ADA Curb Ramp New Construction Inspection Form (Parallel)

NW West Union

23885.56

NW Stewart LN

PARALLEL RAMP (PL)

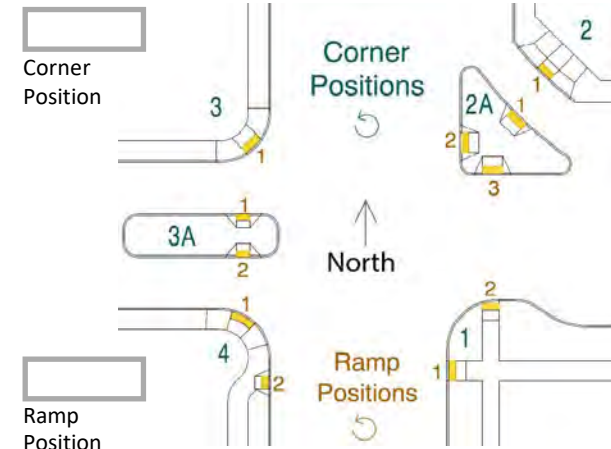
9.6 $\leq 8.3\%$ ☐ $> 8.3\%$ ☒

Comments:
DWS IITD Fails turn space
